HANOVER- REPORT ON AQUIFER TESTING  
OF MUNICIPAL BOREHOLES

October 1987

COMMENT ON Gh 3552 - HANOVER  
(aquifer testing of municipal boreholes)

CONSTANT DISCHARGE AQUIFER TEST NO. 1  
(HR 4 + HR 6)

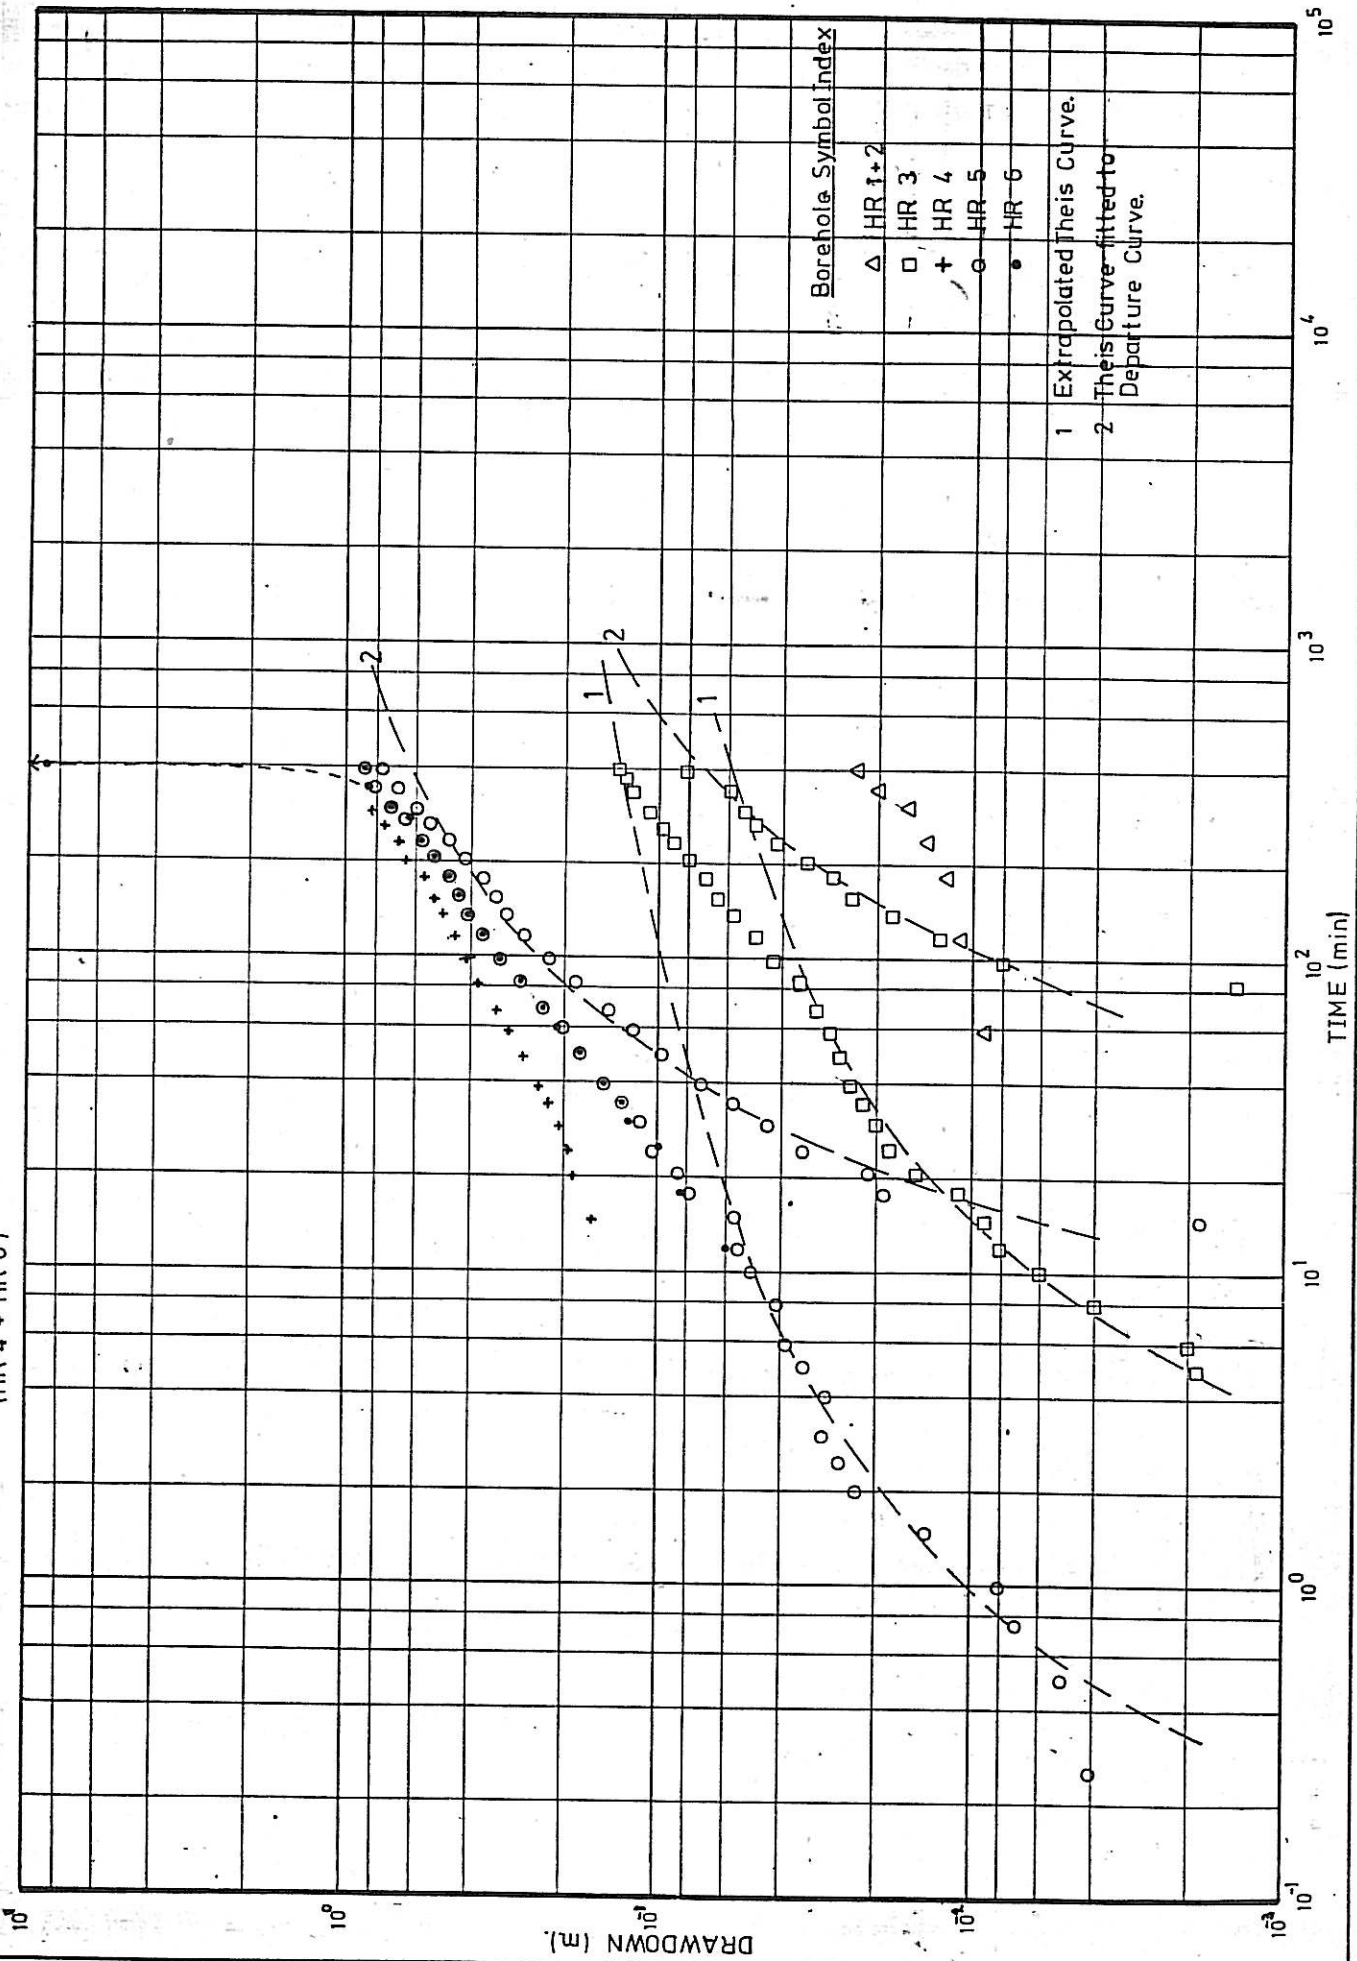
1. Aquifer test no. 1, pumping boreholes HR 4 and HR 6.
  - (a) plotted time-drawdown data of two pumped boreholes (HR 4 and HR 6) show that data points approach the straight lines (on log-log paper) which is a typical linear flow or fracture flow condition in the jointed-fissured rock aquifer. In this situation groundwater flow takes place along the fissures-fractures zone towards the pumping area.
  - (b) The early time-drawdown curves of HR 3 and HR 5 (observation boreholes) follows the Theis' type curve which indicates a radial flow condition in the jointed-fissured rock aquifer at the early stage of pumping. The later data deviates from theis' curve and follows on a straight line which again indicating a linear (fracture) flow condition similar to pumped boreholes.

This can also be concluded that deviation of time-drawdown data from theis' curve is due to a low permeability of some joints-fractures which limits the rock aquifer system at this particular pumping site.

- (c) borehole HR 6 overpumped and some fractures/fissures which possibly have high storage potential were dewatered and consequently pumping rate declined after certain time and pumping level reached close to pump inlet.

- (d) borehole HR 6 was pumped with greater rate, 10  $\ell/s$  (2,85 times greater than HR 4) and showed less or no effect on pumping rate at HR 4 where the pumping rate was fairly constant (3,5  $\ell/s$ ). This indicates that in spite of common joints-fractures system in which HR 4 and HR 6 were intersected, these are some other joints-fractures which contribute water to pumping borehole, HR 6.

- (e) care should be taken in analysing aquifer test data for T and S from HR 3 to HR 6 which drawdown at each borehole affected by two pumping rates (two pumped boreholes). In a multiple well systems when two or more boreholes are operating, the drawdown at any point in the area of influence of these boreholes equals to the sum of the drawdowns caused by each pumped borehole individually.

- (f) hydraulic connection does exist between two well field areas, HR 1-2 and HR 3-6. This noticed during pumping HR 4 and HR 6 and observed some drawdown in HR 1 and HR 2.
- (g) in general, linear flow condition leads to dewatering fractures/joints with time.

CONSTANT DISCHARGE AQUIFER TEST NO 2

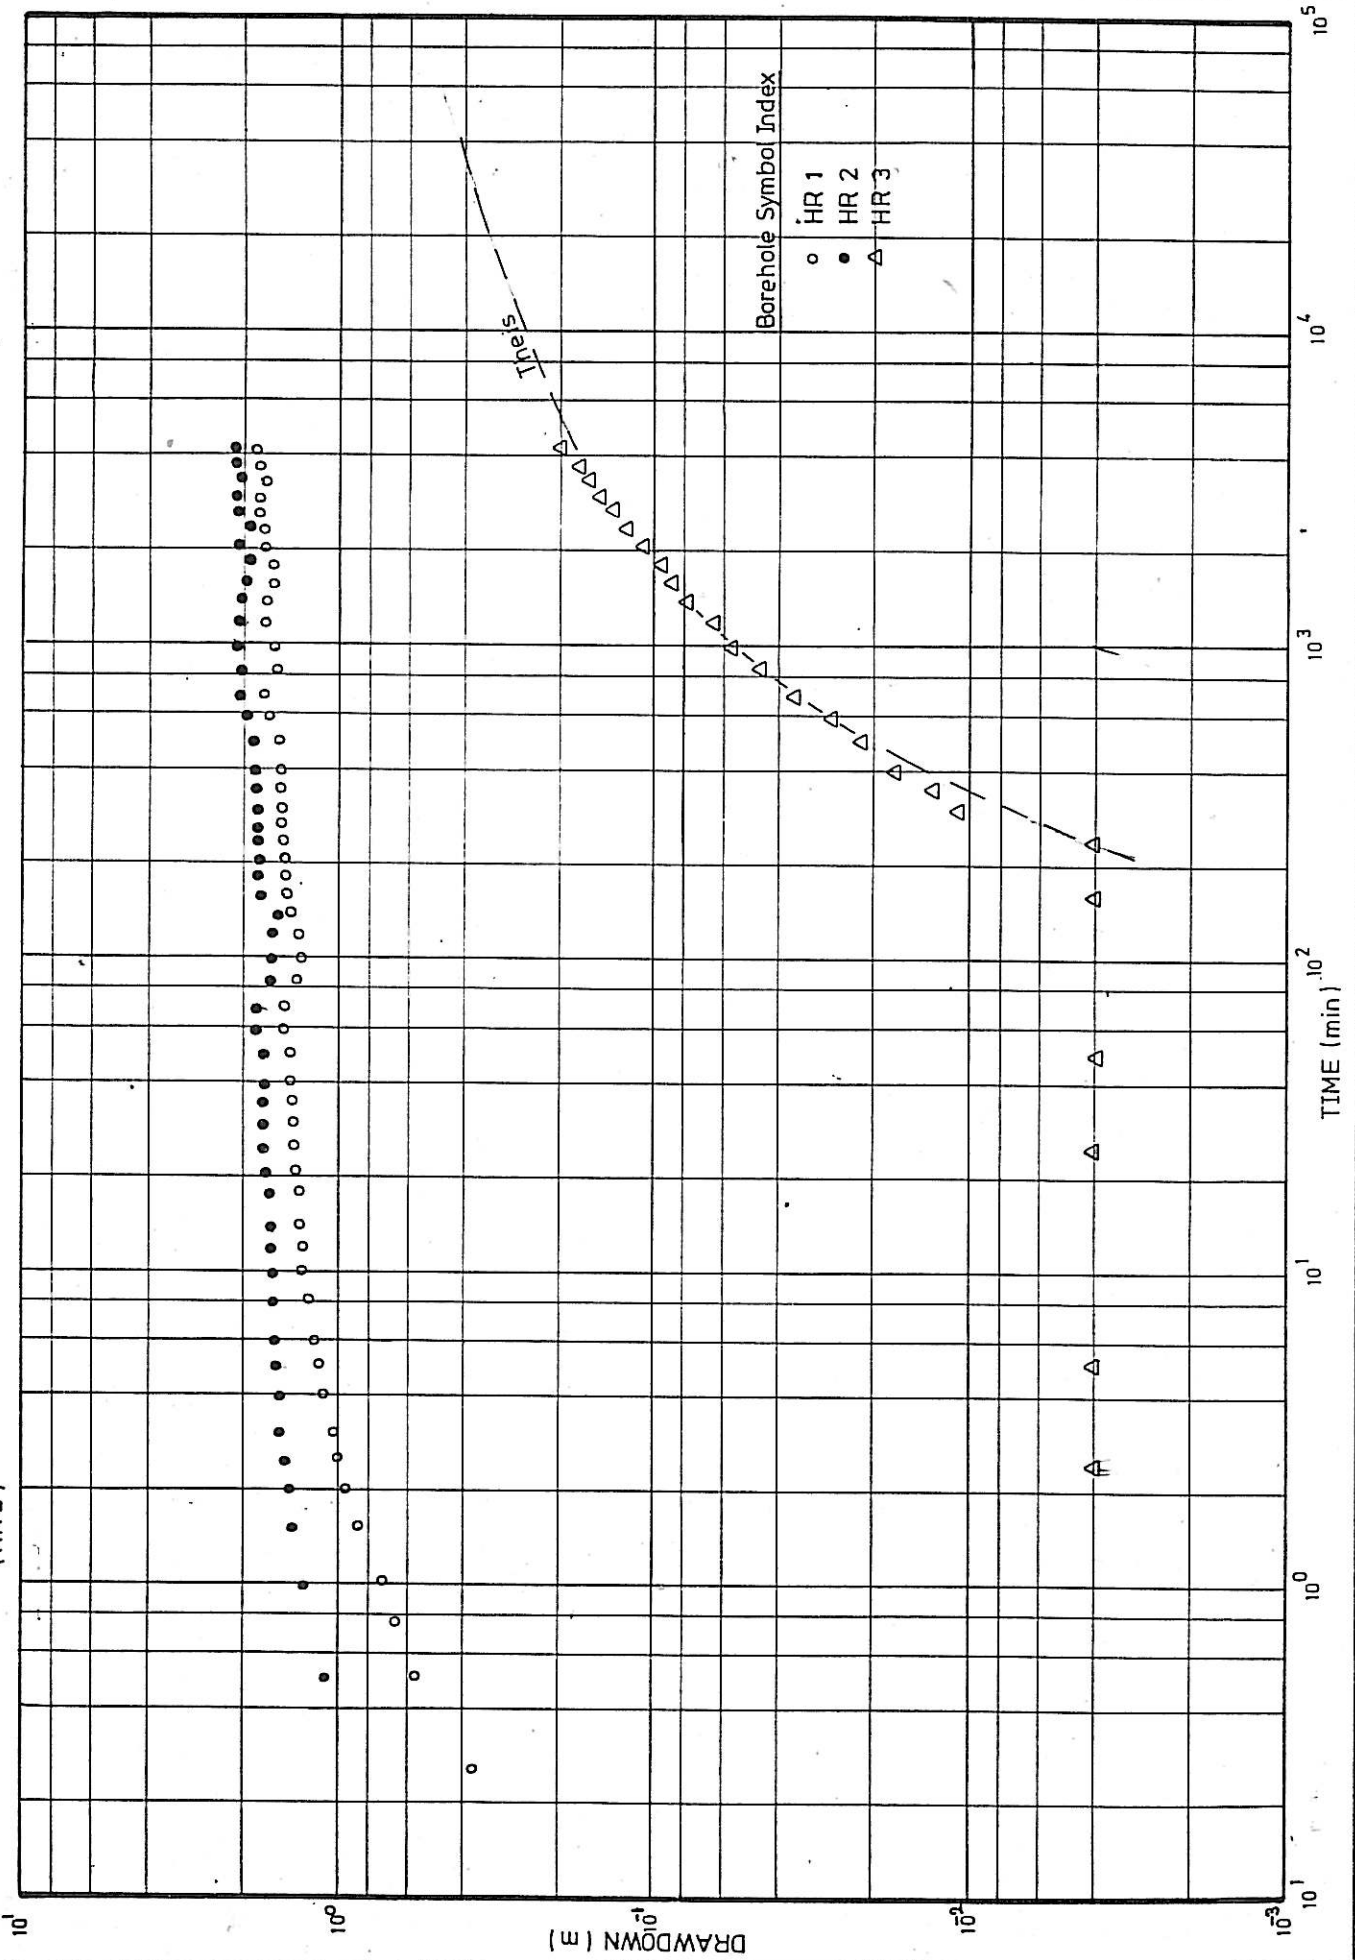
2. Aquifer test no. 2, pumping borehole HR 2.

- (a) plotted time-drawdown data of pumped borehole (HR 2) and observation borehole (HR 1) lie on Boulton's type curves. This indicates that well developed joints/fractures in the rock aquifer act as an unconfined aquifer with gravity drainage. A relatively high specific capacity (Q/D) of 4,45  $\ell$ s/m was obtained at HR 4 after 3 -day pumping with no effect of any low permeable zone on deviating drawdown data from matched curves. This also suggests that geohydrological condition is much better at this area compared with area of test no. 1 and 22% of the total drawdown at HR 2 was recovered after 12 hours termination of pumping.
- (b) observation boreholes HR 3 to HR 6 showed some effects from pumped borehole HR 2. This reveals that two pumping sites 1 and 2 are hydraulically connected through the joints-fractures system.
